# Detailed Site Plan

## NSR Properties

**DSP-19039**

STAFF REPORT

Figure 1: North/Front Elevation

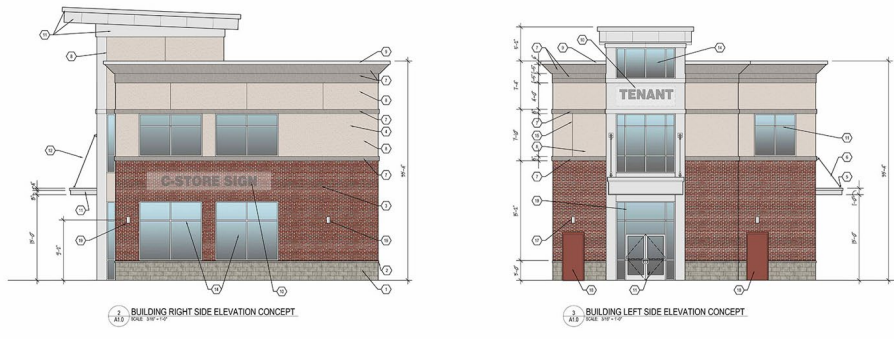
- g. **Architectural Elements, Awnings (page 256)**—The applicant requested an amendment of one standard in this section to allow metal awnings over both entrances and first floor windows on the north side of the building. Staff finds that the awnings provide visual interest, help to highlight the entrances, and provide weather protection. Therefore, staff recommends **approval** of this request, as it will not substantially impair the implementation of the TDDP, and recommends awnings be provided for all pedestrian and service building entrances, as conditioned herein.

- l. Provide overhead awnings for all pedestrian and service building entrances.
- m. Provide details of the building-mounted signage and demonstrate conformance to all applicable 2016 *Approved Prince George's Plaza Transit District Development Plan and Transit District Overlay Zoning Map Amendment* standards.

Figure 4: Multi-Product Gas Dispenser Canopy Signage

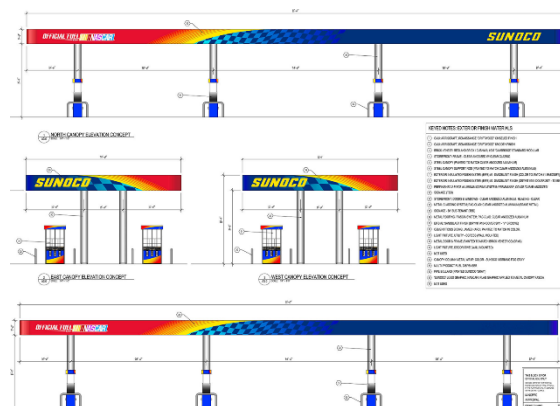
The gas station canopy is three feet tall and fully covered by signage and graphics on all sides. There are no standards for this type of signage as this type of use is not allowed by the TDDP. Signs not expressly identified in, or exempt from, the transit district standards are prohibited (page 193). If the use is approved by the District Council, the design of the gas canopy signage should be addressed to be more harmonious with the building design.

- i. Remove both freestanding signs; all signage shall be affixed to the structures.
- j. Remove the proposed stand-alone automated teller machine (ATM) and associated drive-aisle; any proposed ATMs shall either be affixed to the building exterior or be located within the interior.

Figure 5: New and Existing Freestanding Signage

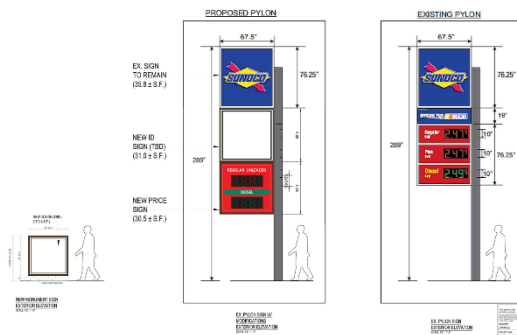
The applicant also proposes to retain the existing 24-foot-high, 97-square-foot freestanding sign and states that this sign is exempt from the TDDP, as it was lawful on July 19, 2016, and is not nonconforming. This exemption does apply currently, but the removal of existing structures and use on the property will make the existing sign no longer legal. The freestanding sign is currently located outside of the frontage zone and exceeds the 8-foot height and 3-foot width limits. A second, 4-foot-high, 17-square-foot freestanding sign is proposed along the Belcrest Road frontage. Both of these freestanding signs require an amendment to the TDDP standard.

- f. **Architectural Elements, Signage, Other Freestanding Signs (page 255)**—Staff identified amendments of two standards in this section for a freestanding sign to be located outside of the Tree and Furnishing Zone (1st sentence), and for the freestanding signs to exceed 8 feet in height and 3 feet in width (2nd sentence). The existing sign along MD 410 that the applicant plans to retain is 24 feet tall, in excess of the allowed 8 feet. The applicant also proposes a 4-foot by 4-foot freestanding sign along Belcrest Road, which exceeds the 3-foot width limit. Neither sign is located in the Tree and Furnishing Zone and the applicant does not have a Retail Zone. Given the importance of signage in frontage design consistency within the Downtown Core area, the requested modifications would not benefit the transit district, and will substantially impair the implementation of the TDDP. Therefore, staff recommends **disapproval** of these requests.

Figure 6: Belcrest Road (Toledo Terrace to Metro Entrance) Illustrative Street Section (page 215)

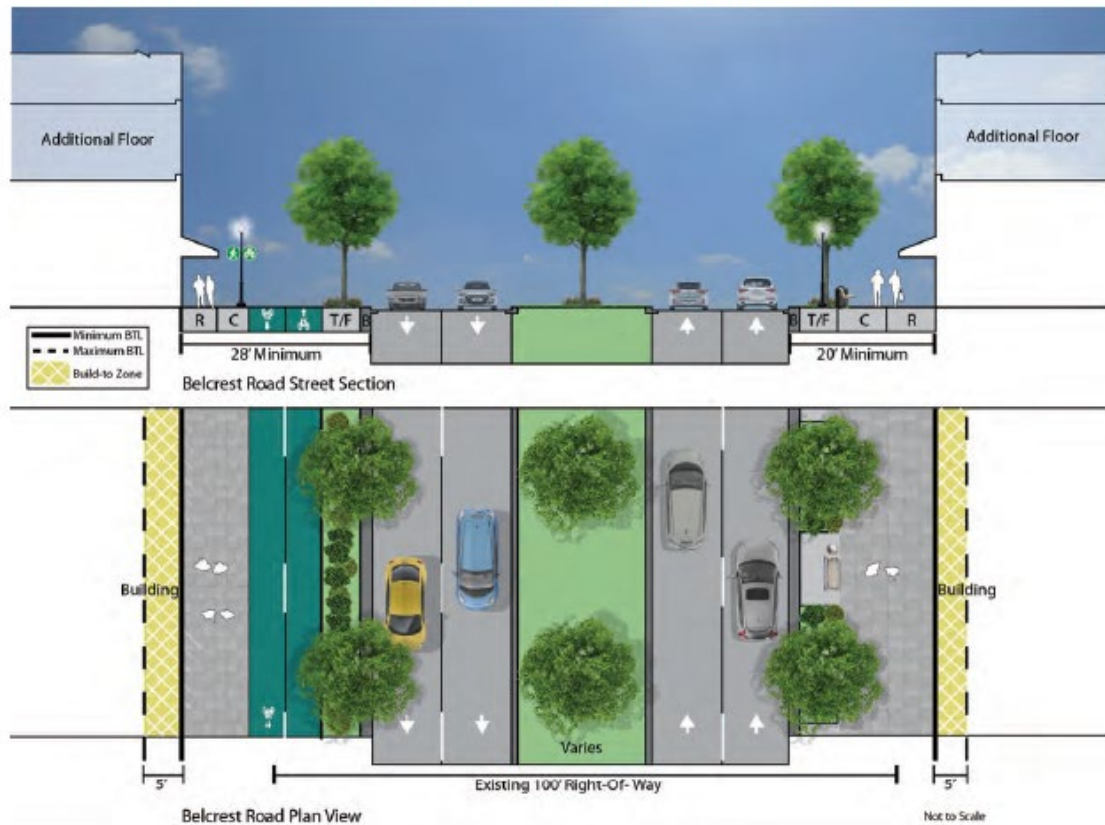
The submitted plan shows a 10-foot-wide sidewalk along the frontage of Belcrest Road but not a cycle track. The applicant has requested an amendment to the TDDP to allow the sidewalk in lieu of the cycle track on the grounds that there is insufficient space to accommodate the cycle track within the dedicated right-of-way. The applicant also states the installation of a cycle track would conflict with standards set by the Prince George's County Department of Permitting, Inspections and Enforcement (DPiE). Staff strongly supports the implementation of the standards in the TDDP. The property is adjacent to the vehicular entrance to the Prince George's Plaza Metro Station and the cycle track would serve as the first and last section of the dedicated bicycle connection. The cycle track is planned to connect the Prince George's Plaza Metro Station to the rest of the transit district along

Belcrest Road. Without this section, the rest of the multimodal network envisioned for the TDDP will be compromised. The TDDP shows a 10-foot-wide cycle track along the property frontage of Belcrest Road. This improvement should be depicted on the DSP and a condition has been included herein requiring this to be added.

The TDDP also has specific guidelines for the frontage of Belcrest Road. The TDDP calls for a cycle track on the west side of Belcrest Road (the subject property). The cycle track shall be 10 feet wide and adjacent to the sidewalk (TDDP page 89).

The applicant shall provide a 10-foot-wide cycle track along their frontage of Belcrest Road, consistent with the TDDP. The frontage along Belcrest Road is required to have 5 feet of Tree and Furnishing Zone, 5 feet of Sidewalk Zone, and a variable width of Retail Zone; totaling a combined minimum depth requirement of 28 feet (including the above-mentioned cycle track) (TDDP page 211).

- c. Provide a 10-foot-wide cycle track along the frontage of Belcrest Road, consistent with the 2016 *Approved Prince George's Plaza Transit District Development Plan and Transit District Overlay Zoning Map Amendment*.
